**Report: TAB Report**  
**Function: Test, Adjust, & Balance**  
**Date: 06/07/2024**

**06-03-24 WAWA #8187 TANNERSVILLE, PA**

# National TAB

image  
06/05/2024

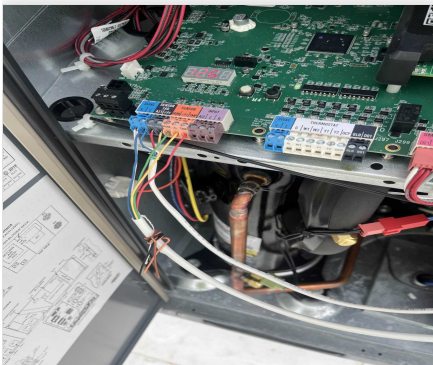
**Issue Name :** EF Securement  
**Description :** The EFs are not secured to the curbs. Recommend securing to the curbs with proper fasteners. (Applies to all Exhaust fans)  
**Created By :** National TAB                      **Assigned To :** National TAB - Tyler Youells  
**Status :** Open  
**Priority :** Medium                                      **Asset Tag :**  
**Originated Date :** 06/05/2024 - Tyler Youells - National TAB

IMG\_6803  
06/05/2024

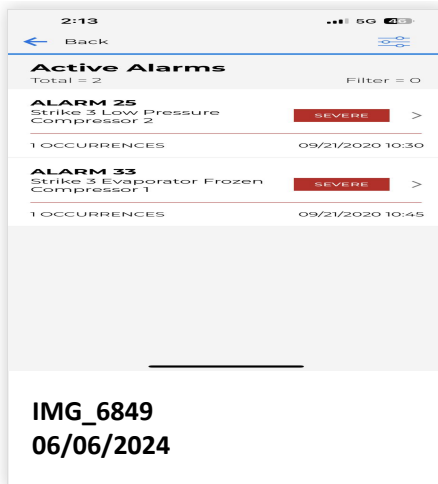
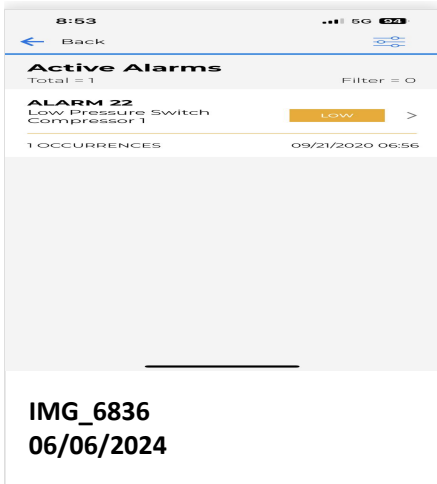
**Issue Name :** RTU Sensor Wiring  
**Description :** RTU sensor wiring is not run per manufacturers specifications. Typical thermostat wiring was used. Spec calls for separate sets of two wire shielded for the humidity sensor and temperature sensor. Recommend replacing wire to ensure sensor will read correctly preventing any space comfort issues.
